Dennis Avenue Health Center, Mandatory Referral, MR2013001

Completed: 09/20/12

Staff recommends approval of the proposed mandatory referral with the following comments:

Figure 1: Proposed Site Plan

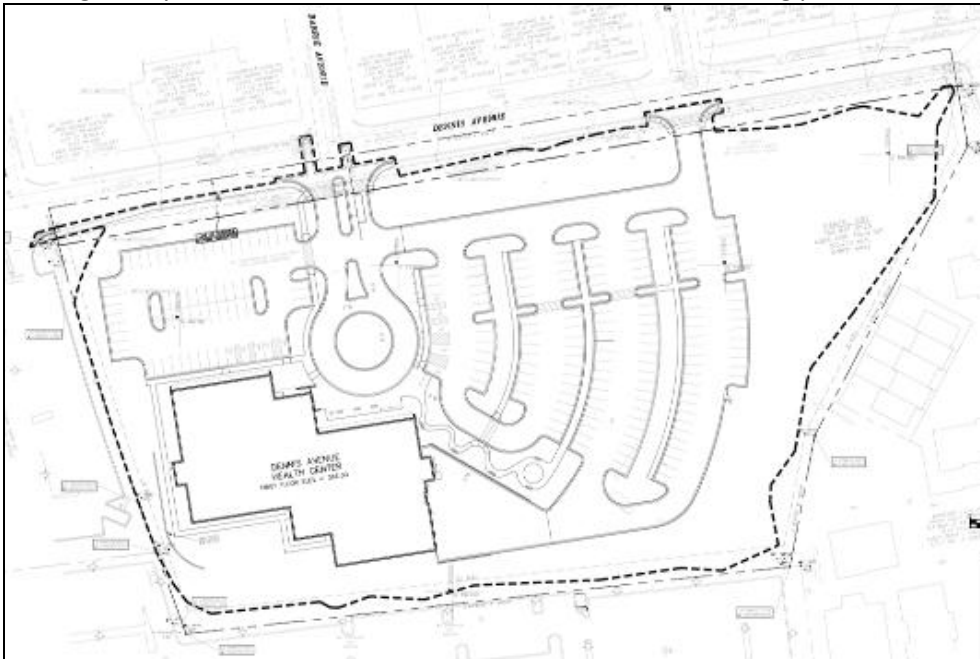
1. Confirm that all sidewalks and crosswalks are American Disability Act (ADA) compliant.
2. Provide a sidewalk and a crosswalk connecting the southeast parking aisle to the building's main entrance. Provide an alternative direct sidewalk in addition to the planted serpentine pathway.

3. Improve the sidewalk fronting the property along the south side of Dennis Avenue to include a minimum five-foot wide green panel between the curb and a five-foot wide sidewalk.

5. Accommodate a minimum of 10 bike spaces among short term (bike racks) and long term facilities (bike lockers or bike storage room).
6. Submit a Preliminary Plan of Subdivision followed by a Record Plat.

ATTACHMENT 2
 SHEET TITLE: **SITE PLAN**
 SHEET NUMBER: **C201**

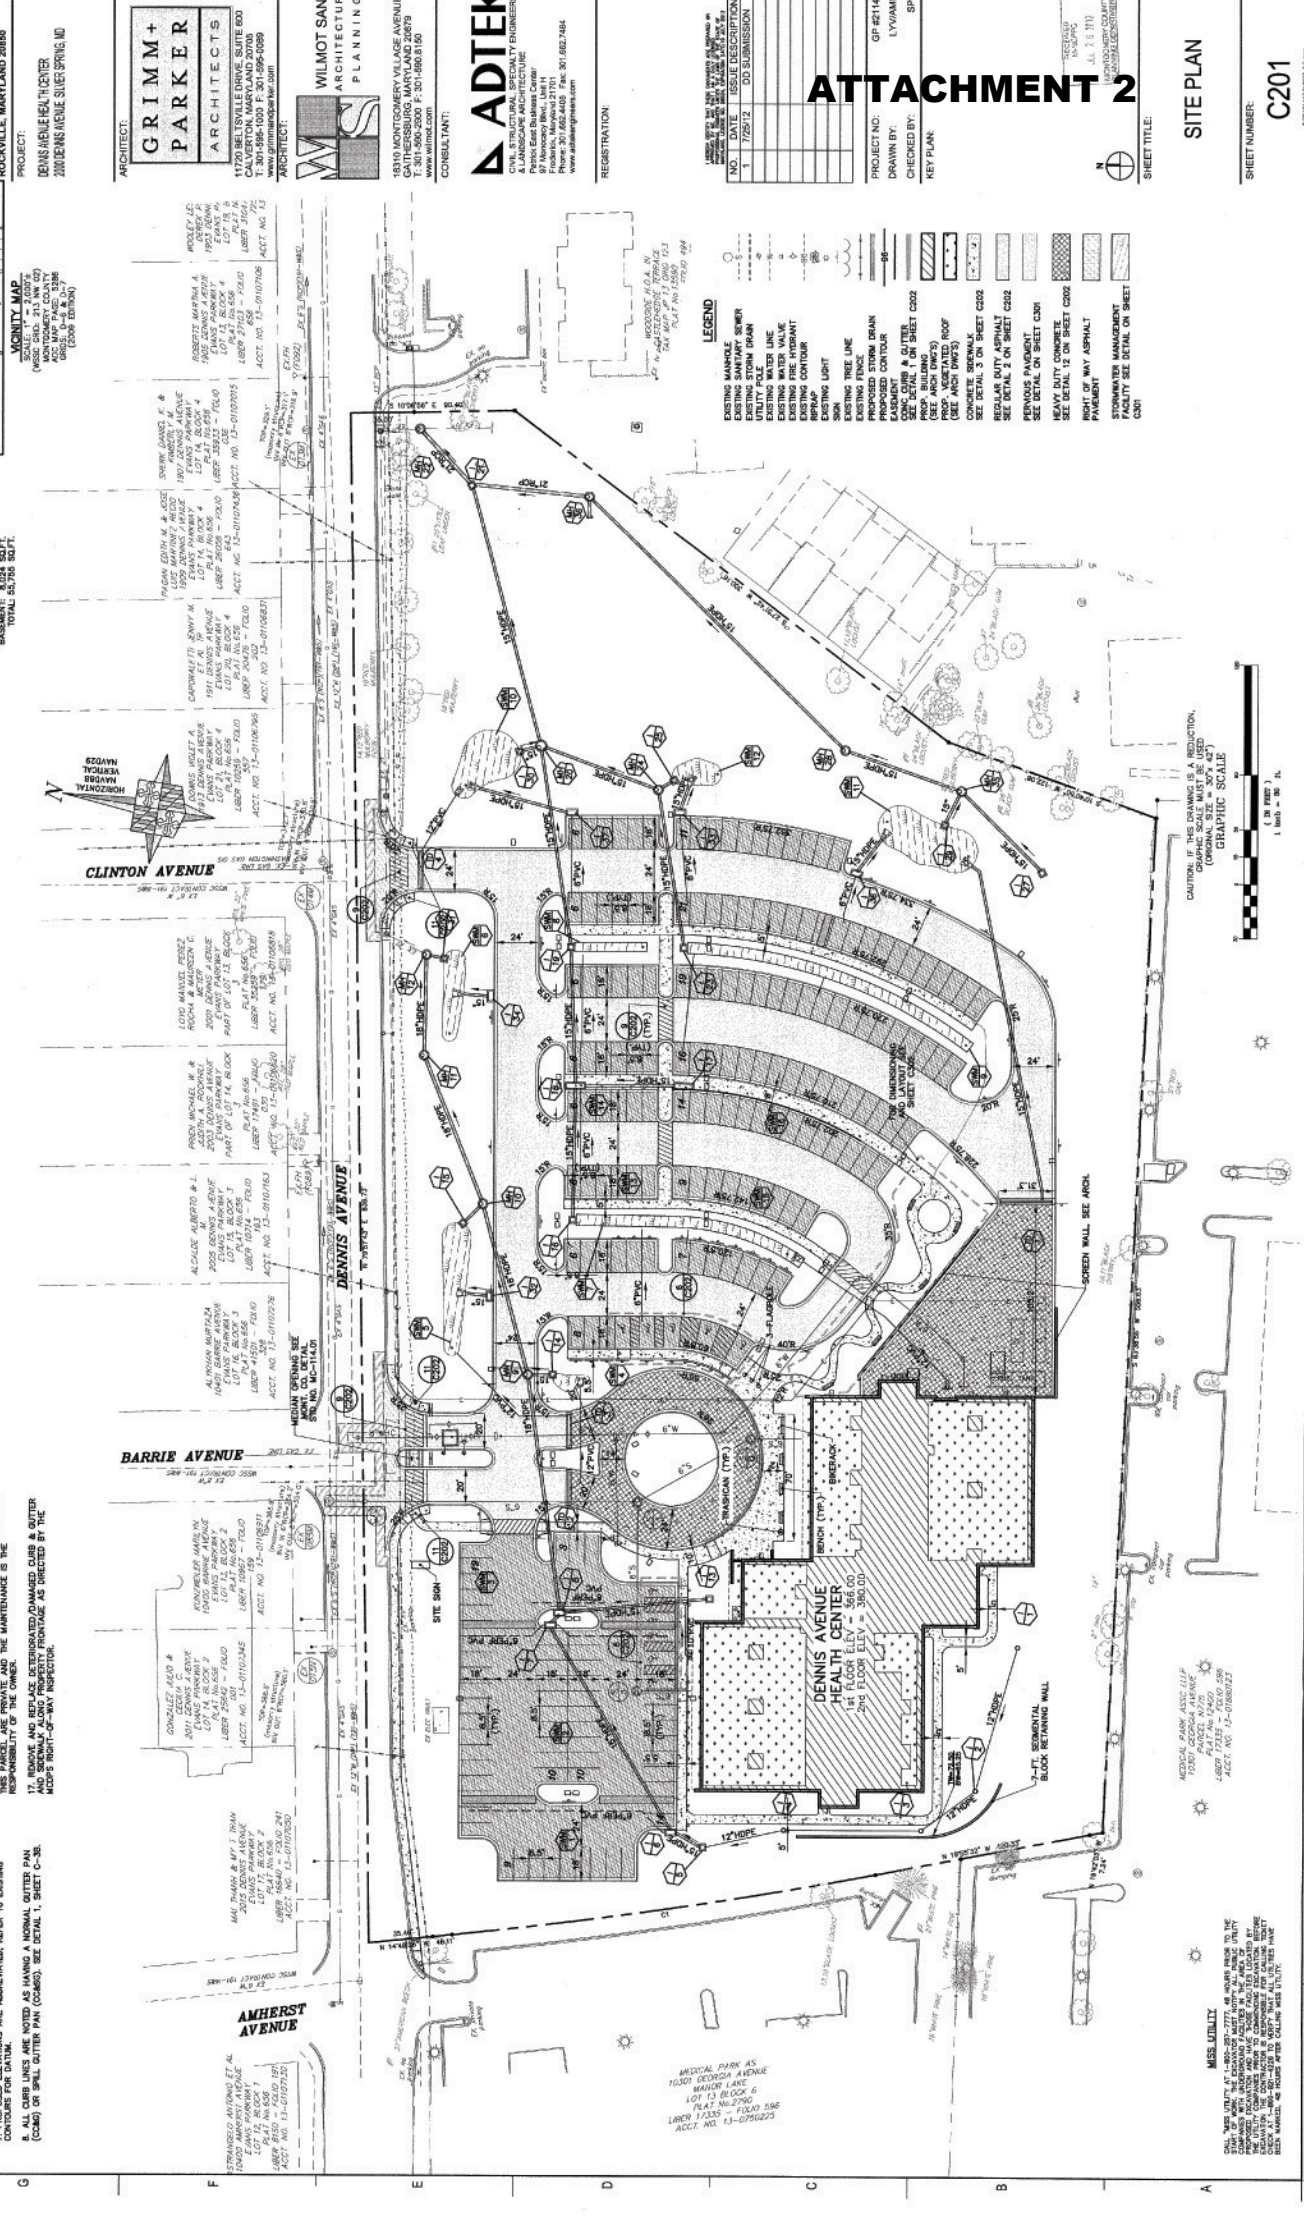
The current proposal doubles the existing number of parking spaces from 105 to 212 spaces. However, Article 59-E requires a minimum of 267 parking spaces for a medical clinic of 53,432 GSF. Therefore the proposal provides 55 fewer parking spaces than required. The Applicant analyzed their Program of Requirements and determined there are three categories of uses proposed in the building: medical office; non-medical general office; and warehouse. The Applicant analyzed parking needed of each category and the result of this analysis indicated a total of 212 parking spaces to be sufficient. The Applicant also observed the amount of “overflow” parking accommodated along the entry drive aisle when the existing lots were full.
